**Transmission Symptom - Transmission Oil Leaks Out When Driving on Race Circuits:  
Replacing Vent Line for Clutch Chamber (SY 130/19)**

Vehicle Types: **911 GT3 (991)/911 GT3 RS (991)**

Subject: **Vent line for clutch chamber**

*Vent line for clutch chamber*

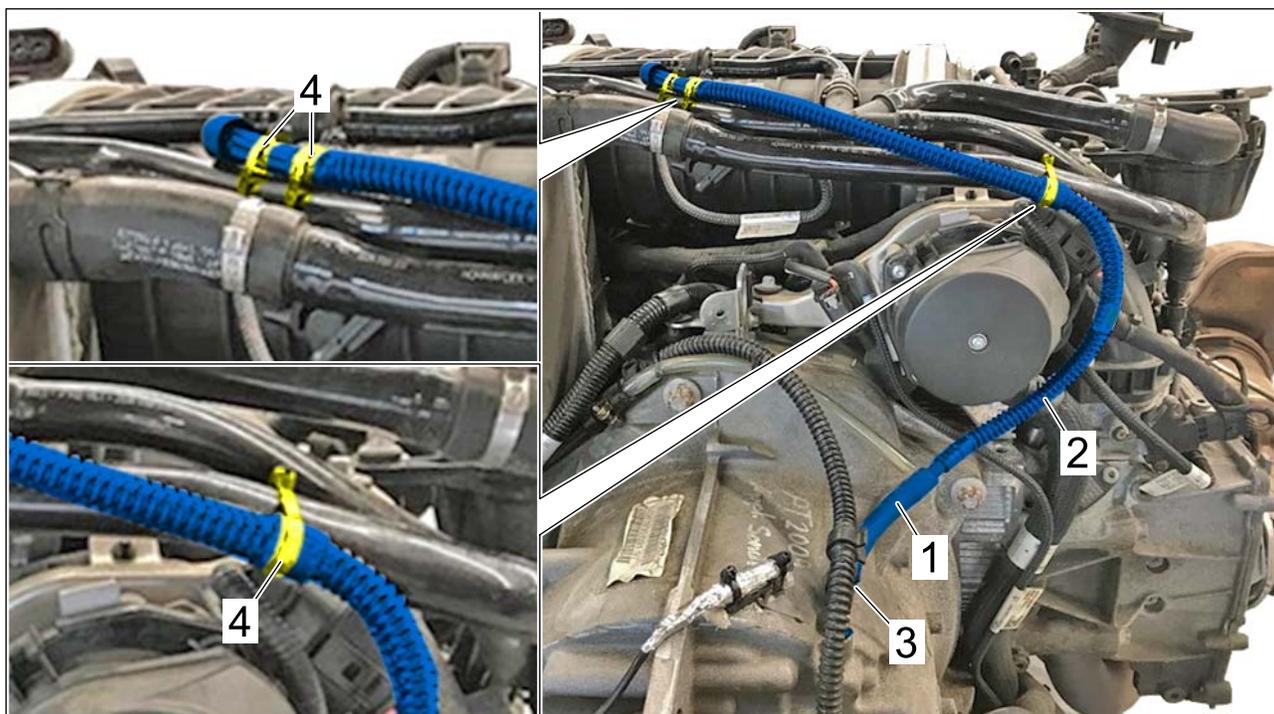
Symptom: Transmission oil leaks out of the vent line for the clutch chamber when driving on race circuits.

Cause: Highly dynamic driving on race circuits at high engine speeds causes oil foaming and can result in an oil leak from the PDK vent line on the clutch side in some cases.

Remedial Action: Replace vent line for clutch chamber and re-route it.

Work Procedure: 1 Disconnect vent line for clutch chamber ⇒ *Vent line for clutch chamber -1-* from breather pipe ⇒ *Vent line for clutch chamber -2-*.

2.1 Fit **new** hose adapter (9GT301280) ⇒ *New vent line for clutch chamber -1-* on **new** vent line for clutch chamber (9GT301063) ⇒ *New vent line for clutch chamber -2-* and breather pipe ⇒ *New vent line for clutch chamber -3-*.

2.2 Route **new** vent line for clutch chamber (9GT301063) ⇒ *New vent line for clutch chamber -2-* so that it is routed continuously upwards as shown and secure with combination holders at positions ⇒ *New vent line for clutch chamber -4-*.
